**Town of Gorham
Planning Board Meeting
January 9, 2023**

ITEM 4 - Private Way - Correale, Anthony – a request for a proposed private way off the end of Libby Ave. Zoned, SR. Map 50, Lot 12-2. The applicant is represented by David C. St. Clair Jr., P.L.S., St. Clair Associates.

**TOWN OF GORHAM PLANNING BOARD
PRIVATE WAY REVIEW
FINDINGS OF FACT
FOR
CORREALE, ANTHONY – LIBBY AVENUE PRIVATE WAY**

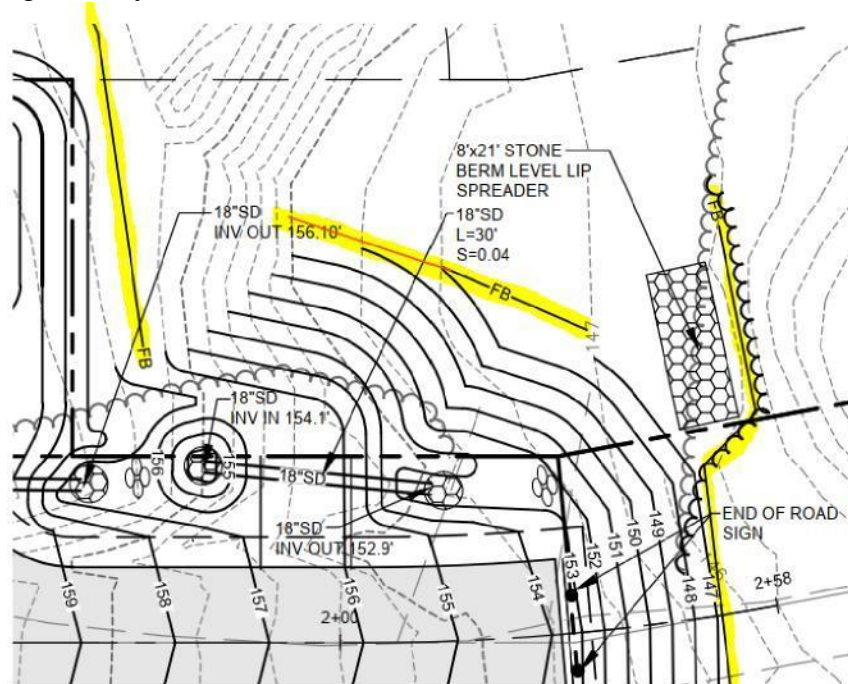
- a. Filter barrier on the westerly side of the road should be extended southwesterly farther along the slope to capture all runoff from the proposed disturbances. See sketch below. Proposed filter barrier is highlighted in yellow, and extension is shown in red.

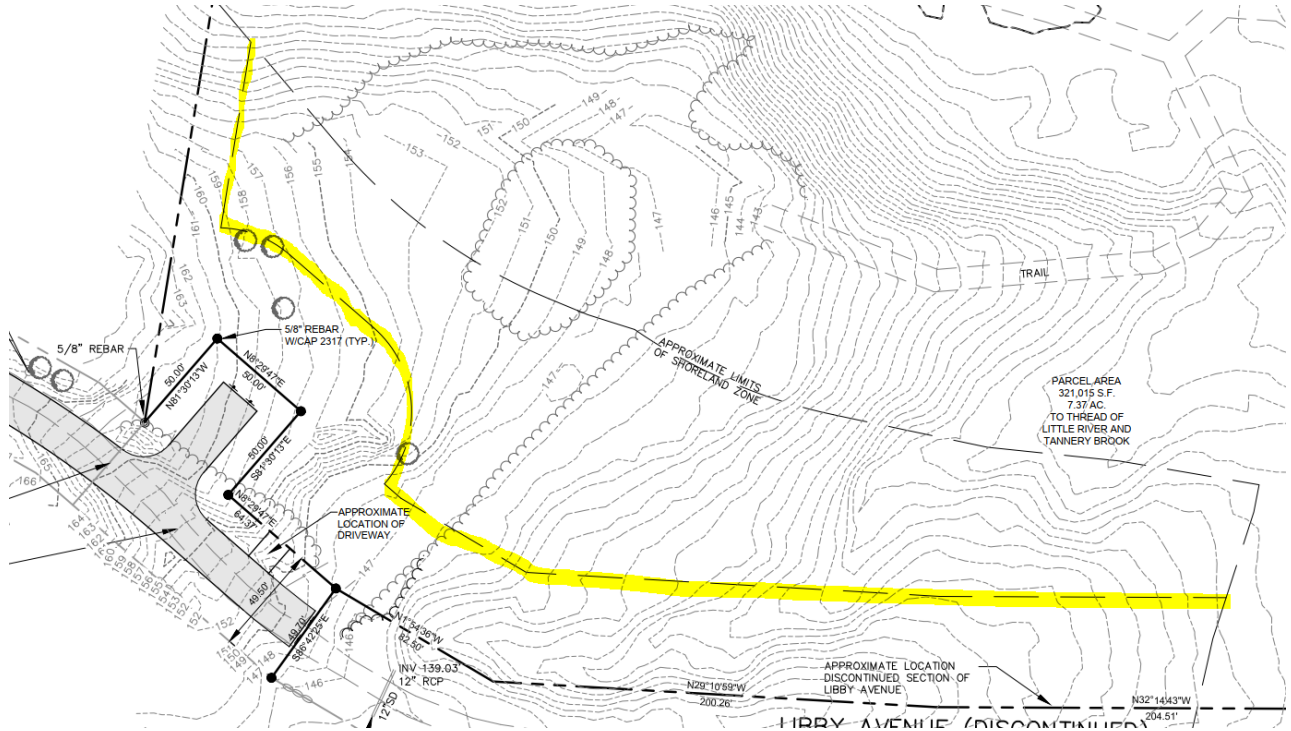
1. WP Original Comment 2: Shoreland zone is shown as a closed polygon rather than an offset line from the river/stream. Consider updating to clarify.

WP Follow Up Response: Please clarify what the line highlighted in yellow below is. This line is unlabeled and the same line type as the shoreland zone line, so we originally thought it was erroneously included as part of the shoreland zone, creating a closed polygon as described before.

Applicant Response: The Shoreland Zone line has been updated to extend past the property limits of the limit of the Applicant’s property. This change does not affect anything in the Applicant’s site.
